S62A/2025/0133 Stoke Lodge Playing Fields, West Dene, Shirehampton, Bristol BS9 2BH

Works to install 8no. CCTV poles and 24 cameras

**Fig.1: Plan submitted
by Cotnam School
for application
20/01826/F**

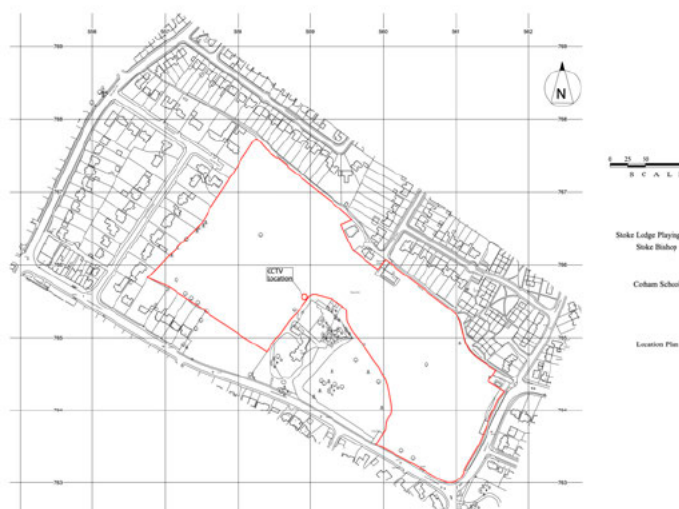
- On the site location plan, the blue continuous line (labelled as the school boundary) is artificial; the school boundary is the lease line which is marked as a dashed pink line. Many significant and protected trees are within the boundary of the land and within the school's leased area. The submitted plan also shows a red line which is said to be the 'extent of the planning application area'. This red line broadly follows the route of the proposed cabling, although it has an outcrop in the centre of the plan which is a further artificial measure to include proposed trees within the 'planning application area', while having in fact excluded all the actual trees on the site. The red line on the site location plan should properly include all necessary land, including access points etc. The redline boundary marked on the plan provided by the applicant is neither accurate nor sufficient. The school's previous application for one CCTV tower (BCC LPA reference 20/01826) correctly provided a redline boundary matching the lease line (see fig.1). The same site boundary used for the previous single CCTV tower application must also apply to this application for 8 towers since the whole site is affected in terms of visual and amenity impact – there is no proper reason to do otherwise. The applicant's site location plan is invalid.

Fig.2: Proposed additions to the Definitive Map (ROW/3363939)

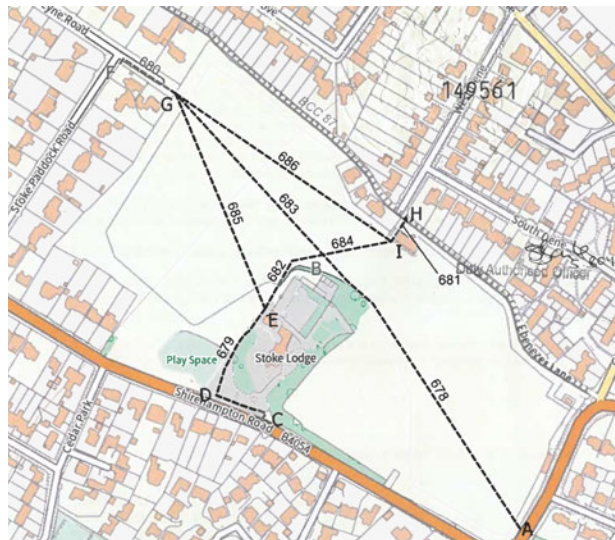
The applicant admits at Q6 of the application form that there are several claimed rights of way 'adjacent to the site' but has intentionally failed to address the impact of the proposal on these rights of way. In fact, the four rights of way cross the site itself (see fig.2). The Council as landowner supports the addition of these routes to the Definitive Map and consideration at a public hearing is due to take place next year (ROW/3363939). At least one proposed CCTV tower (camera 5, and possibly camera 4) would directly obstruct a right of way.
